TITLE	PARTIAL MEZZANINE/LOW ROOF FRAMING PLAN - AREA B (SEQ-1)		
MADE BY	DATE	CONTRACTOR	JOB No.
PDS	11/30/2020		20028
CHKD BY	DATE	ARCHITECT	ENGINEER
JSY	11/30/2020		
			SHEET NO.
			1E1
			REV.
			A

**PARTIAL MEZZANINE/LOW ROOF FRAMING PLAN @ AREA-B (SEQ-1)**  
 (REF: S2.2 & 1/A1.3)  
 [TOP OF STEEL ELEVATION 114'-0 1/2" U.N.O.]

TITLE		ROOF SECTIONS @ AREA B		
MADE BY	DATE	CONTRACTOR	JOB No.	
PDS	11/30/2020		20028	
CHKD BY	DATE	ARCHITECT	ENGINEER	SHEET NO.
JSY	11/30/2020			1E14
				REV.
				A

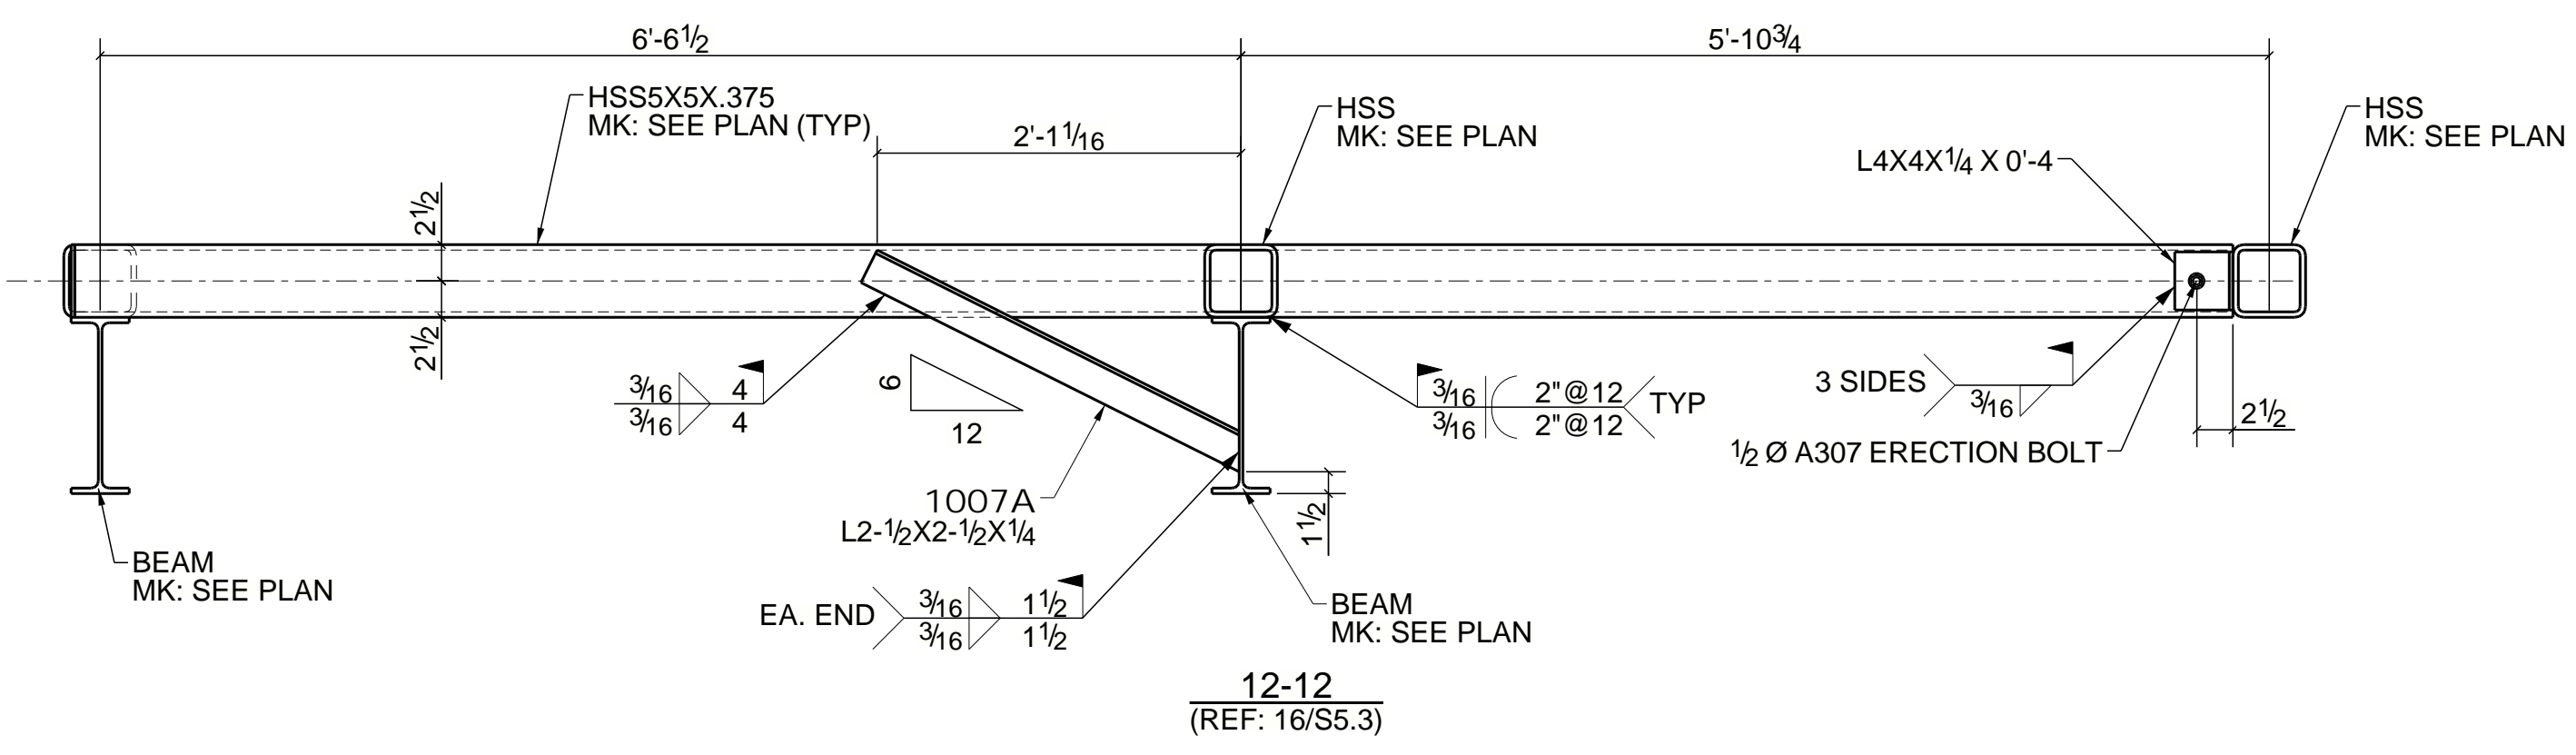
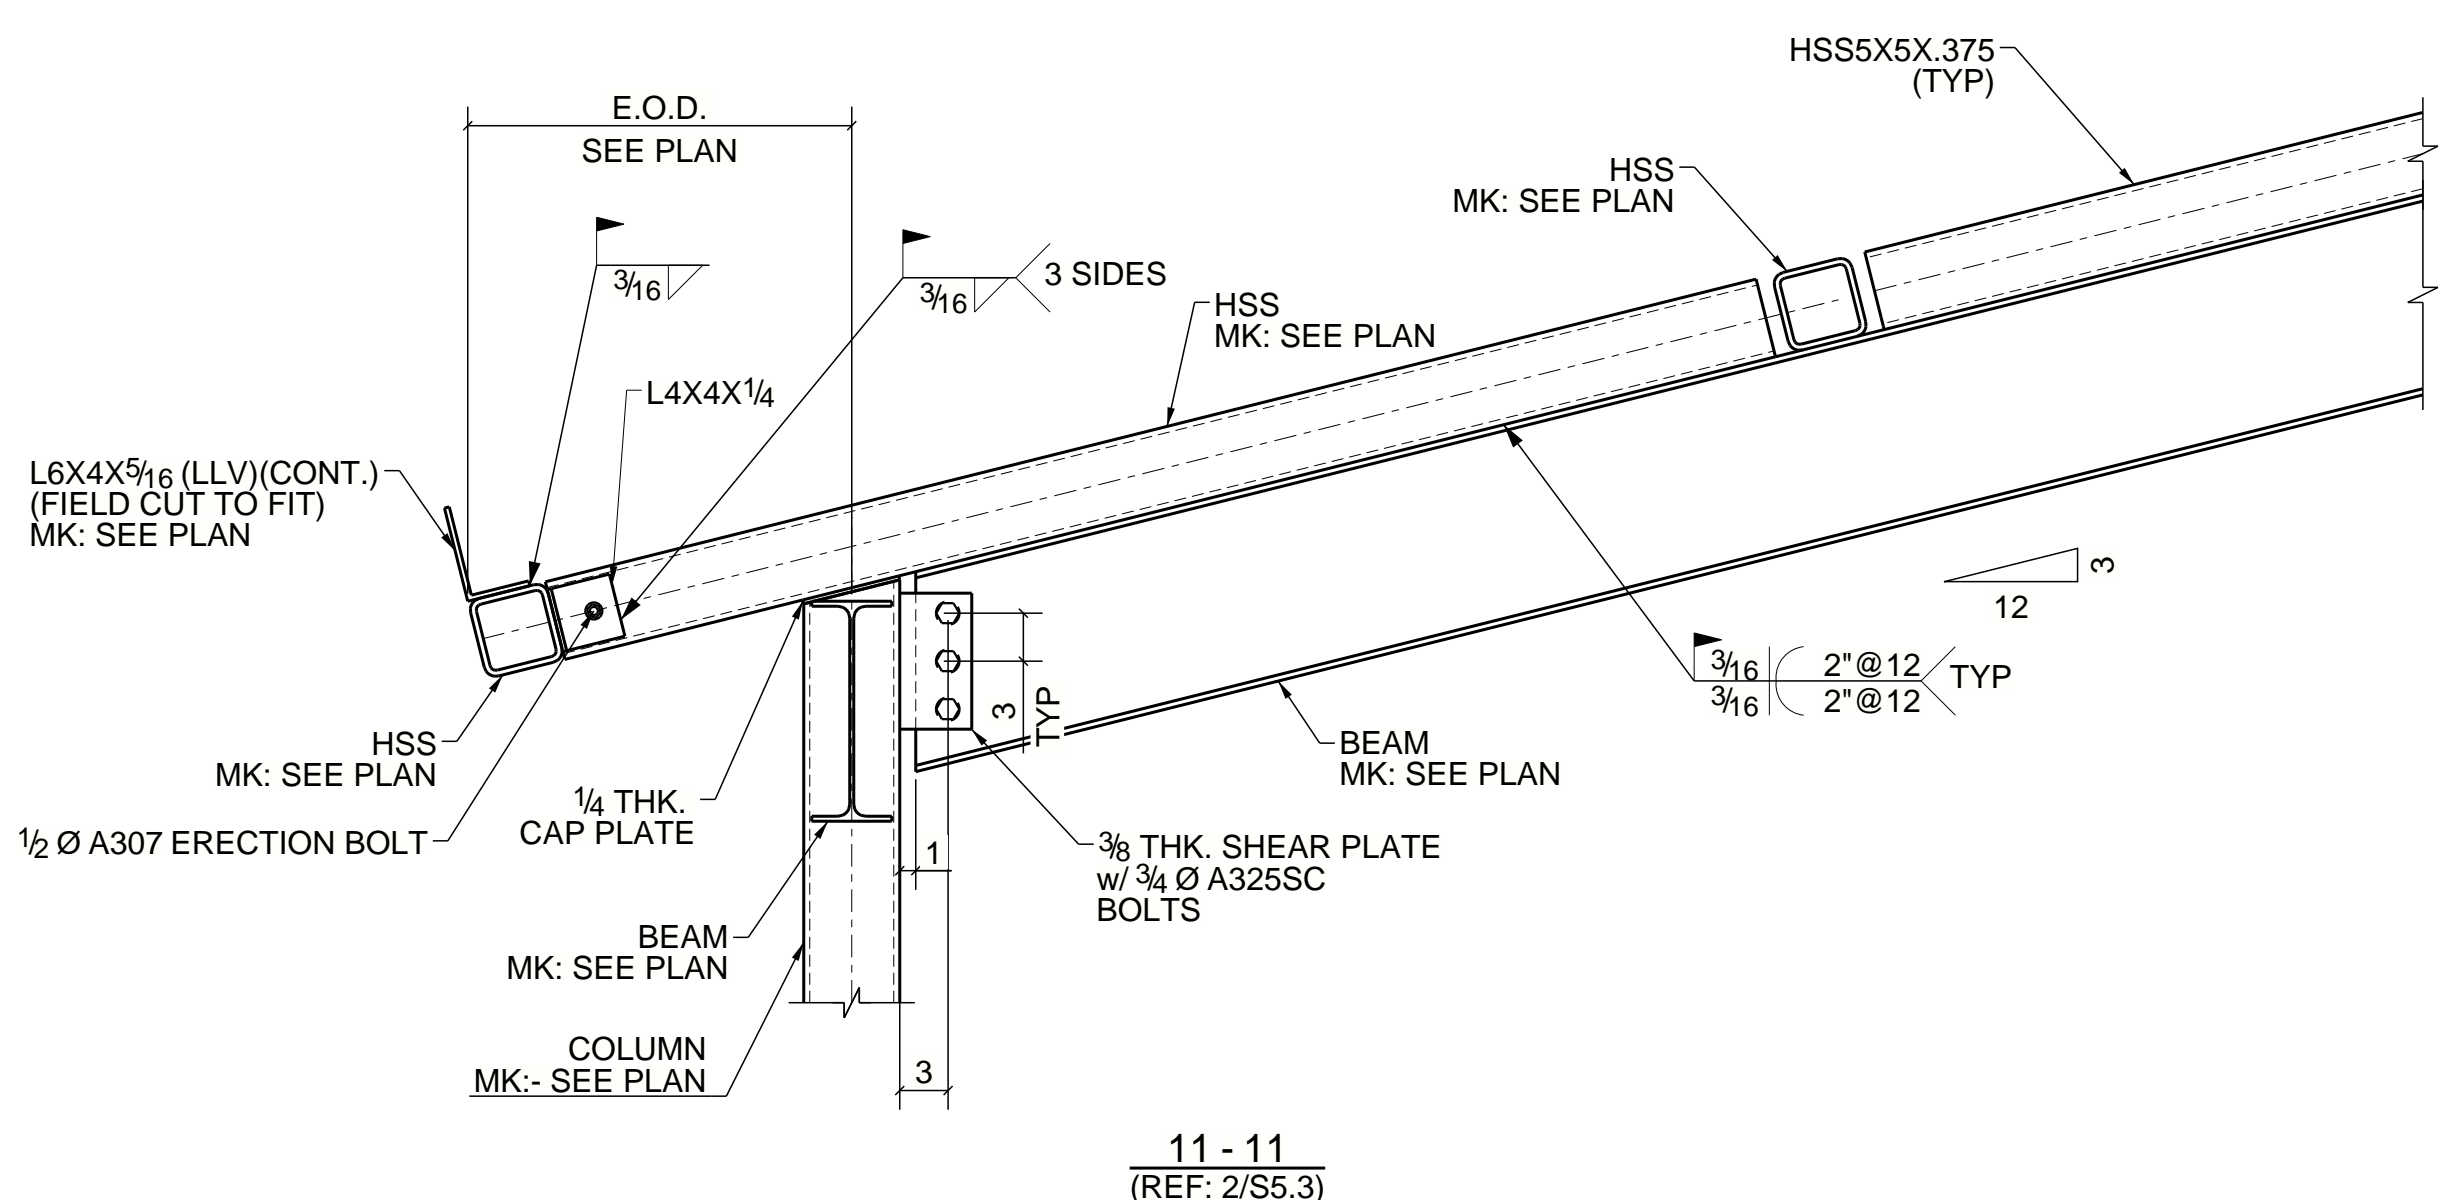
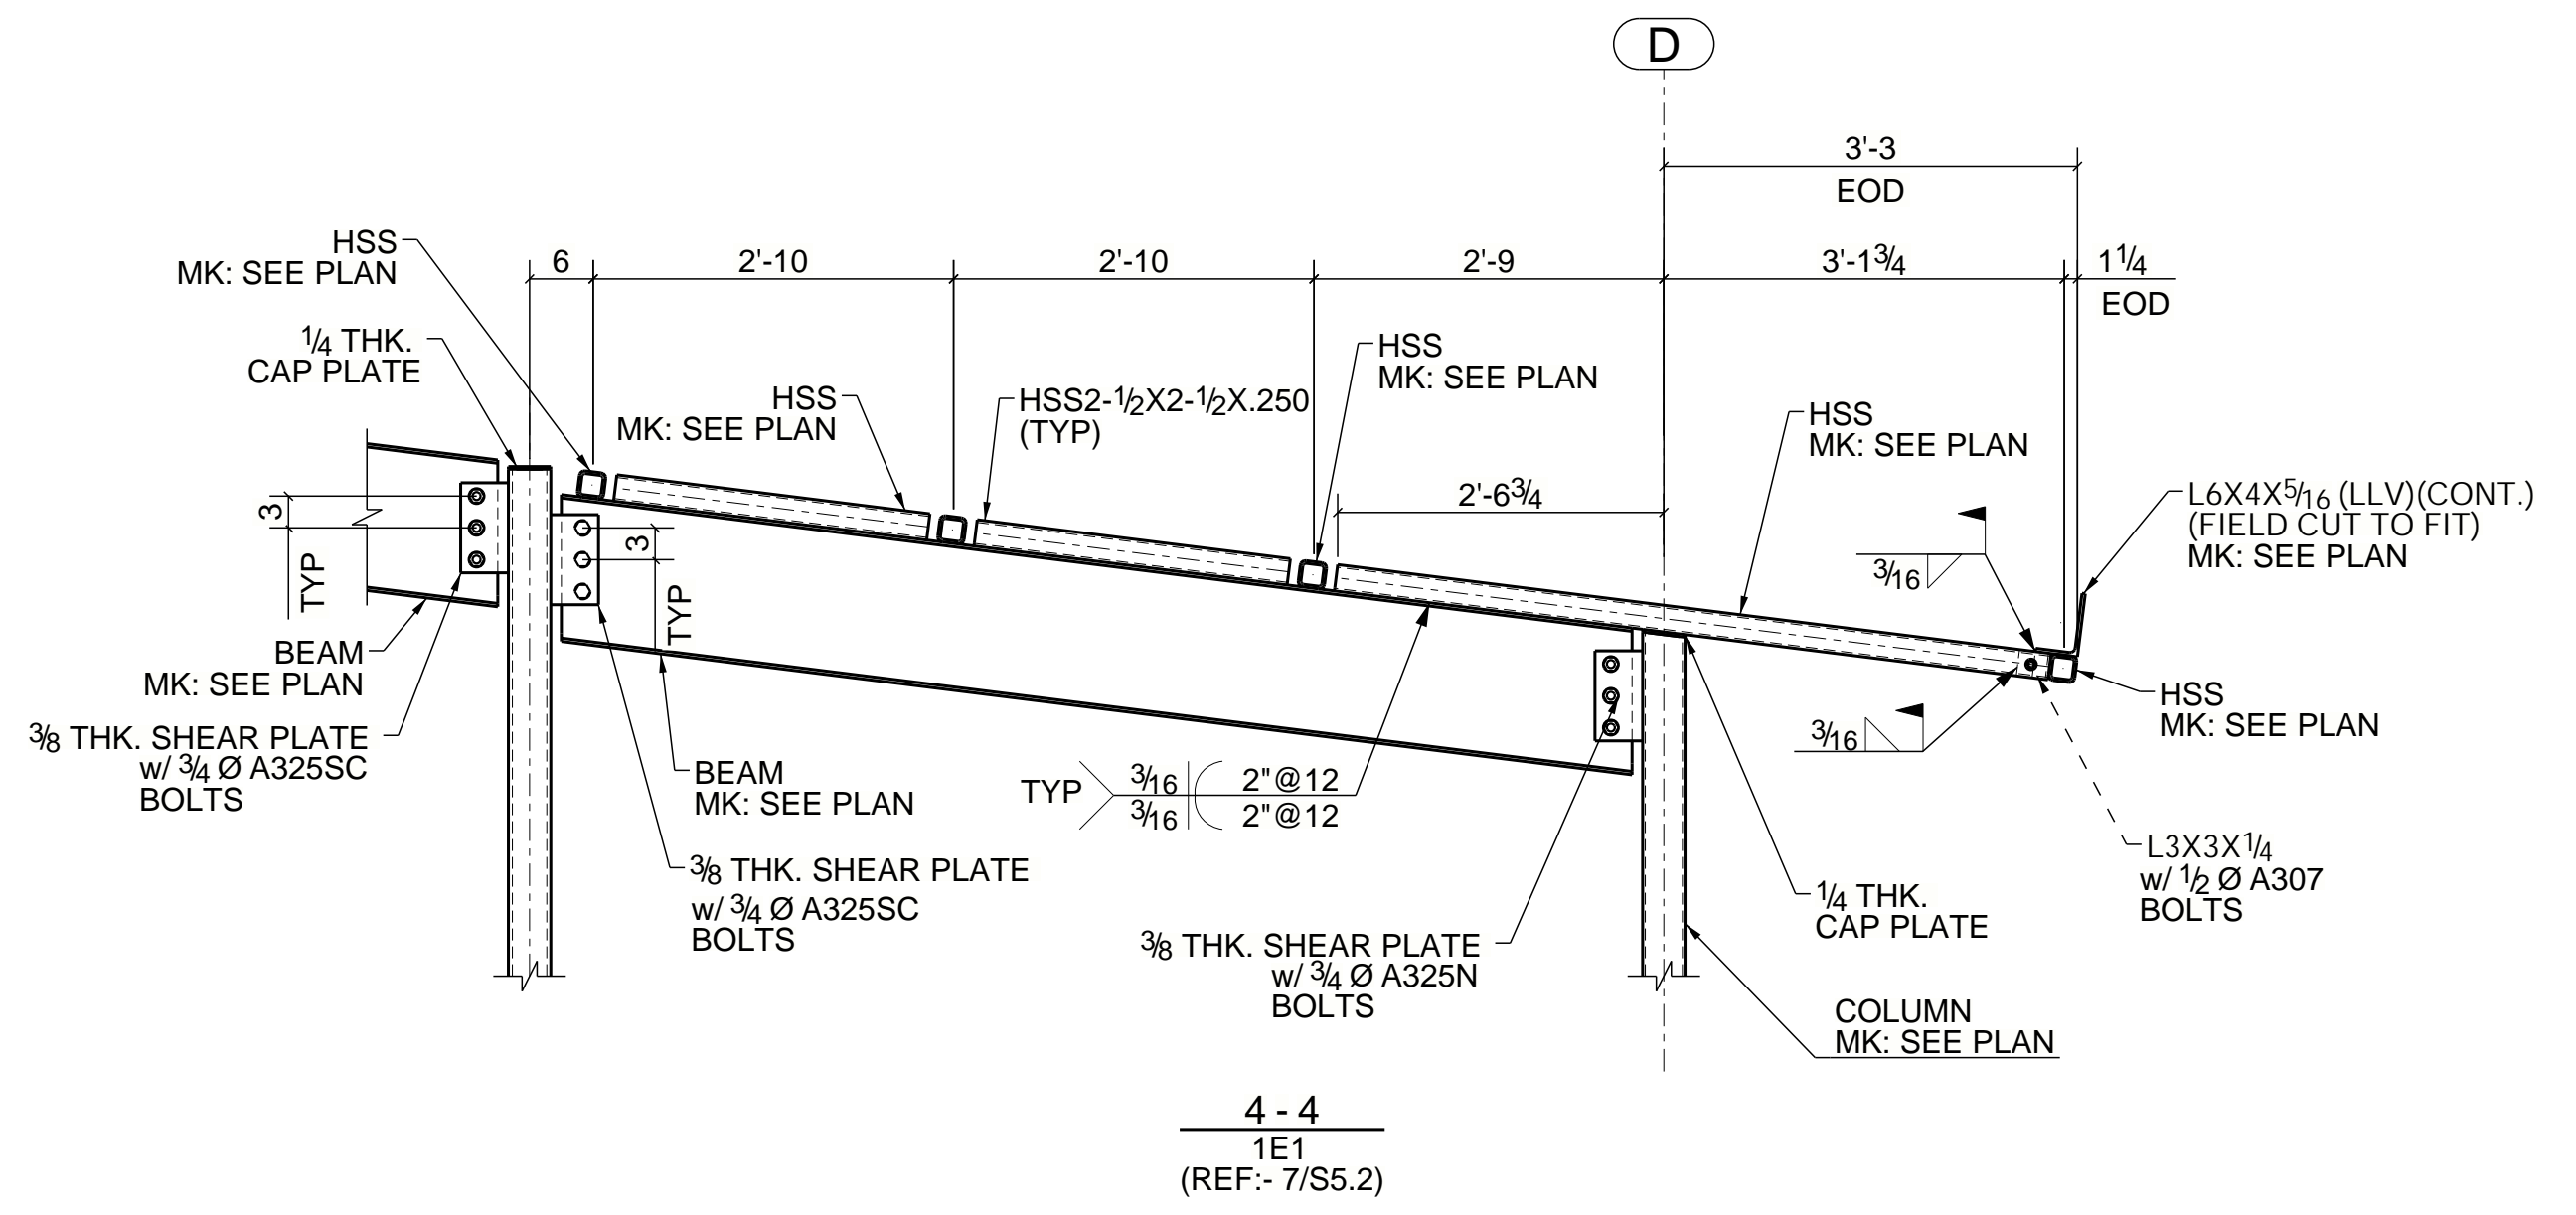
NOTE #1:- WE HAVE NOT CONSIDERED STIFFENER PLATE WHERE THERE IS NO CONNECTION ABOVE BEAM. PLEASE VERIFY/SUGGEST.

NOTE #2:- PLEASE VERIFY/CO-ORDINATE THE JOIST PANEL POINT DIMENSION WITH JOIST SUPPLIER.

NOTE #3:- WE HAVE FOLLOWED ANGLE SIZE L2 1/2X2 1/2X1/4 IN PLACE OF L2 1/2X2 1/4X1/4 AS SHOWN IN DETAIL 1/S5.2, BECAUSE L2 1/2X2 1/4X1/4 IS NOT AVAILABLE IN AISC. PLEASE REVIEW/CONFIRM.
